DESIGNED BY: DF/CD	PER TOWN OF ROLESVILLE COMMENT	10/02/2023			
	DRAWN BY: DF/JWM	PER TOWN OF ROLESVILLE COMMENT	08/01/2023			
	REVIEWED BY: DF	INITIAL SUBMITTAL	06/01/2023			
	5440 WADE PARK BLVD, SUITE 102 RALEIGH NC 27607 WWW.BCEINC.COM NC LICENSE #C-4397					
LENNAR CORPORAION 1100 PERIMETER PARK DRIVE, SUITE 112 MORRISVILLE / NORTH CAROLINA / 27560						
PARKER RIDGE 82 SCHOOL STREET ROLESVILLE / NORTH CAROLINA / 27571						
ENLARGED GRADING PLAN (1 OF 6)						
NOT FOR CONSTRUCTION						
FILE NUMBER: 8430-03						
DATE: 10/02/2023						
C4-1

DESIGNED BY:	DF/CD
	DRAWN BY:	DF/JWM
	REVIEWED BY:	DF
	PER TOWN OF ROLESVILLE COMMENT	10/02/2023
LENNAR CORPORAION	PER TOWN OF ROLESVILLE COMMENT	08/01/2023
	PER TOWN OF ROLESVILLE COMMENT	06/01/2023
	INITIAL SUBMITTAL	REV
	5440 WADE PARK BLVD, SUITE 102 RALEIGH NC 27607 WWW.BCEINC.COM NC LICENSE #C-4397	©2023
PARKER RIDGE	1100 PERMETER PARK DRIVE, SUITE 112 MORRISVILLE / NORTH CAROLINA / 27560	
	ENLARGED GRADING PLAN (4 OF 6)	
	FILE NUMBER:	8430-03
	DATE:	10/02/2023
	NOT FOR CONSTRUCTION	
	C4-4

PARKER RIDGE

STORM SEWER TABLE

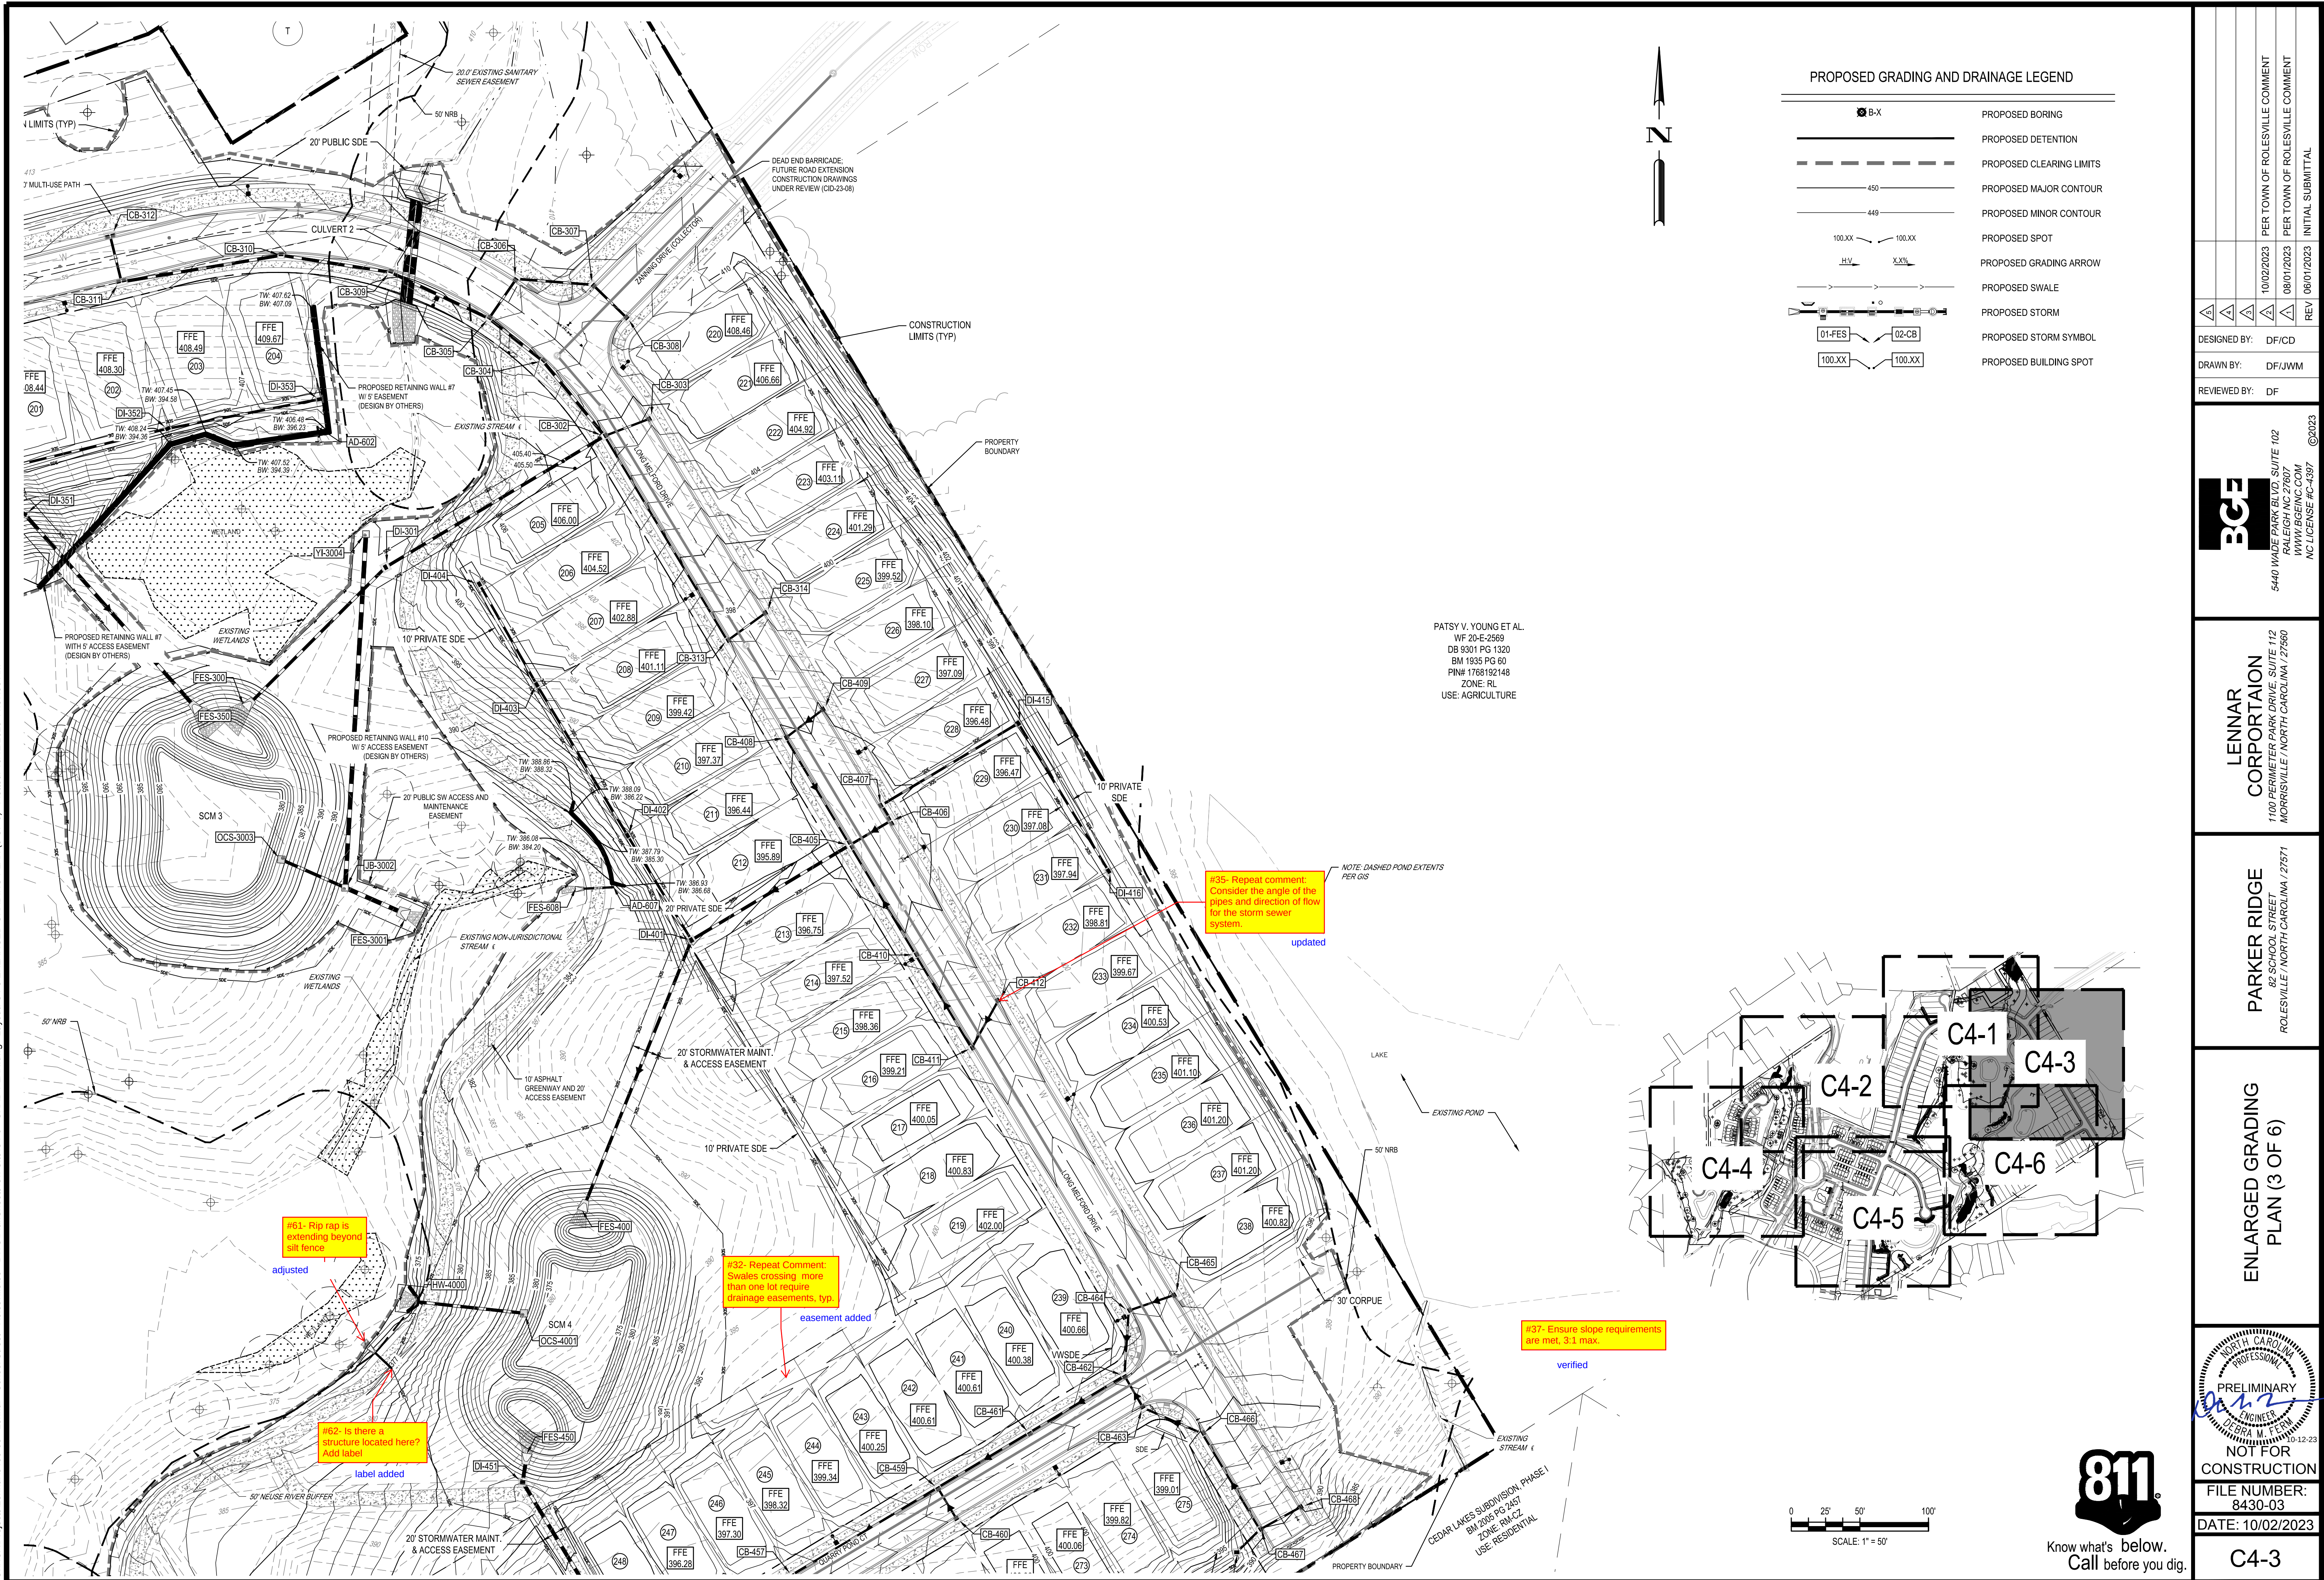
#E3- label contour (verify
this is not a low point)

#37- Grades steep in this
section

#43- Contours should
connect into existing

#64- The surrounding
grading and the FFE's
don't appear to match
up.

#43- contours don't
appear to tie in to
existing correctly

#35- Repeat comment:
Consider the angle of the
pipes and direction of flow
for the storm sewer
system

#37- Grades going up to
wall are too steep,
consider extending wall or
looking into some other
solution.

#61- Rip rap is extending
beyond tree protection
fence and limits of
disturbance

#48- label contours in this
area

ENLARGED GRADING
PLAN (5 OF 6)

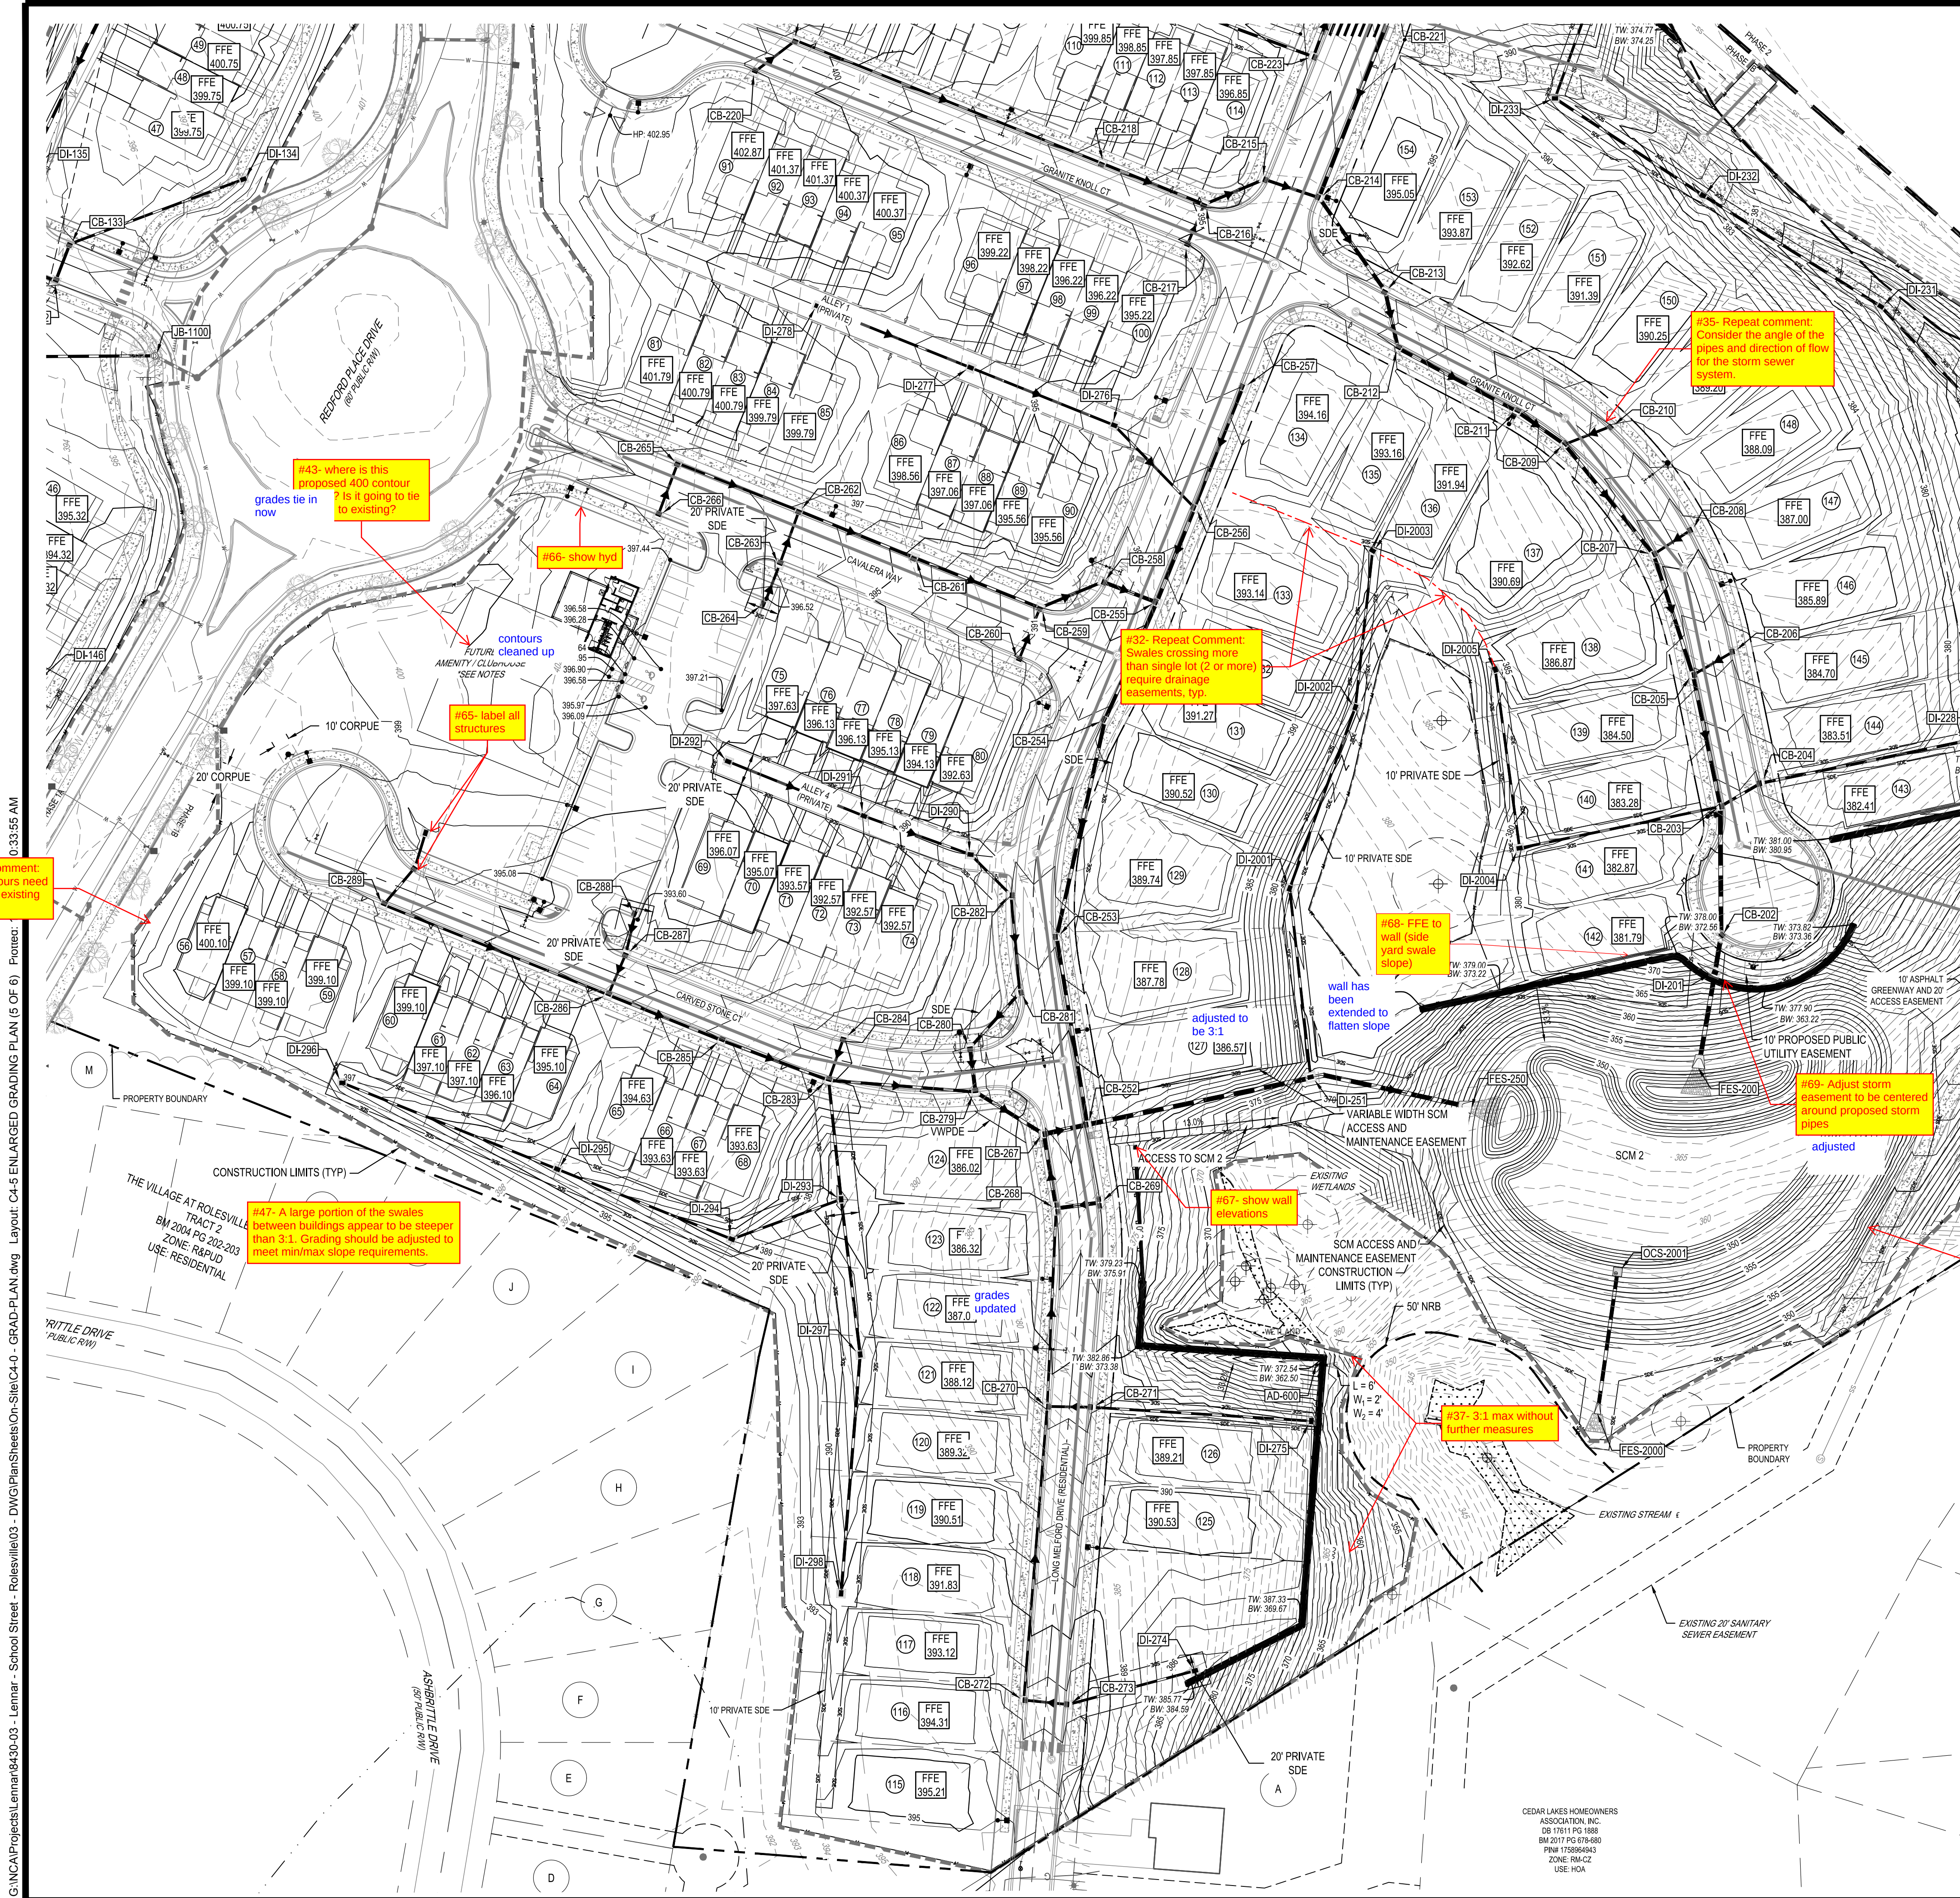
#71- any opportunity to lower to allow W/L to go over storm? see profile C6-5

#72- If possible, refrain from using the same numbers for structure labels so as to minimize any confusion
